**RE: PHILLIPS 66 @ ALAMEDA & I-25 (C18-D36). UPDATED GRADING AND DRAINAGE PLAN FOR BUILDING PERMIT AND SO #19 PERMIT APPROVALS. ENGINEER'S STAMP DATED JANUARY 12, 1998.**

**RE: PHILLIPS 66 @ ALAMEDA & I-25 (C18-D36). GRADING AND DRAINAGE PLAN  
FOR BUILDING PERMIT AND SO #19 PERMIT APPROVALS. ENGINEER'S  
STAMP DATED OCTOBER 20, 1997.**

**DRAINAGE REPORT**  
**FOR**  
**PHILLIPS 66**  
**@ ALAMEDA AND I-25**

EXHIBIT 1

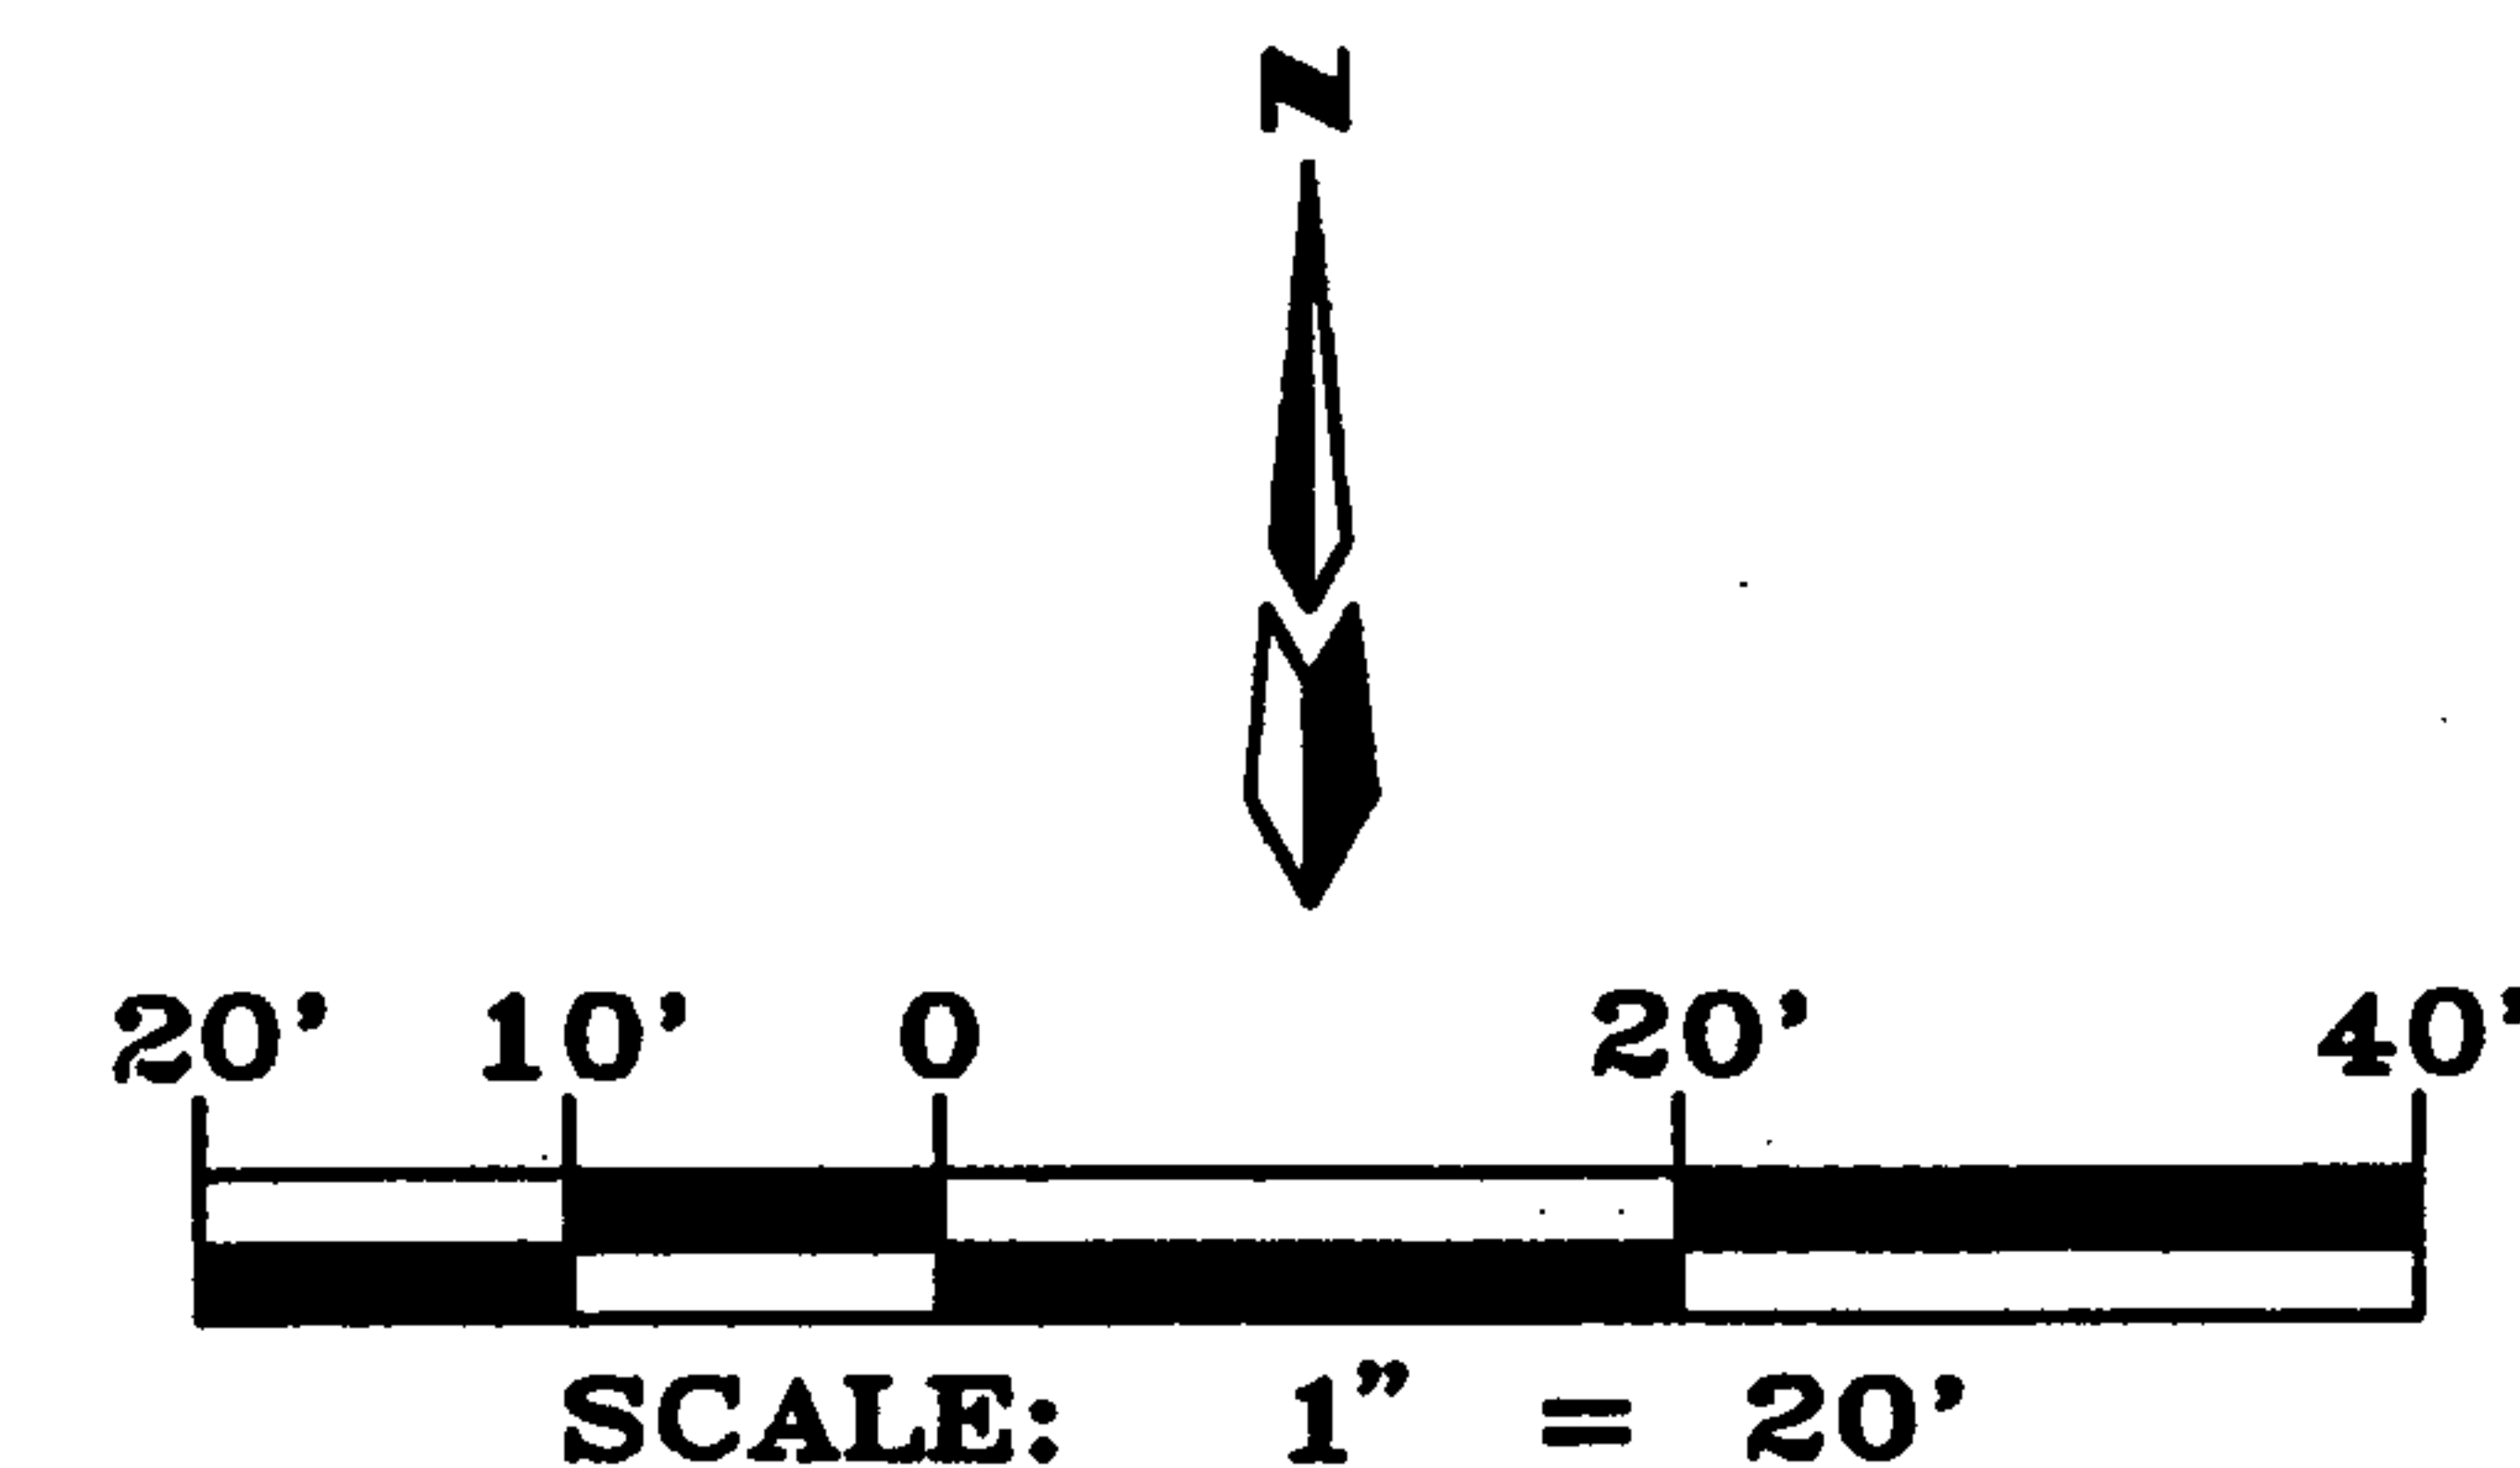
*Cross lot drainage assessment?*

*27. no ~ better to temporarily retain water*

*Requires a replot of drainage plan for Ramada*

*Cross lot  
drainage assessment*
